SERVICE INFORMATION LETTER
SIL1022 January 9th, 2023 rev 00

Saft battery type A275CH1 P/N 415808
Nut vertically restraining the cells inside the battery box
P/N correction

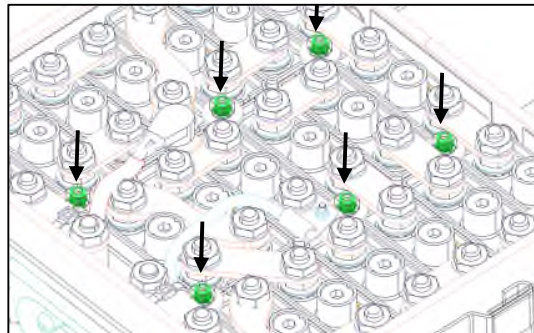
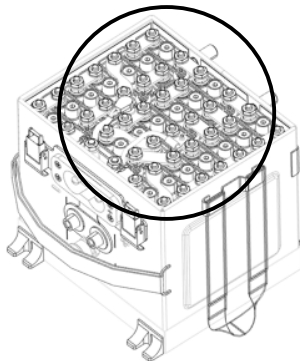
Replacement of the nuts vertically restraining the cells (identified in green and by arrows below) must be done in the frame work of a general overhaul.

Previous nut definition (before this SIL):

HFR Nut M4 A4-80 Saft (F6177) P/N 217201, according to NFE 25411 or equivalent.
Quantity per battery: 6 each.

New nut definition (after this SIL):

HFR Nut M4 A2-70 (Nylstop self-locking) Saft (F6177) P/N 102288,
according to DIN 985 or equivalent.
Quantity per battery: 6 each.
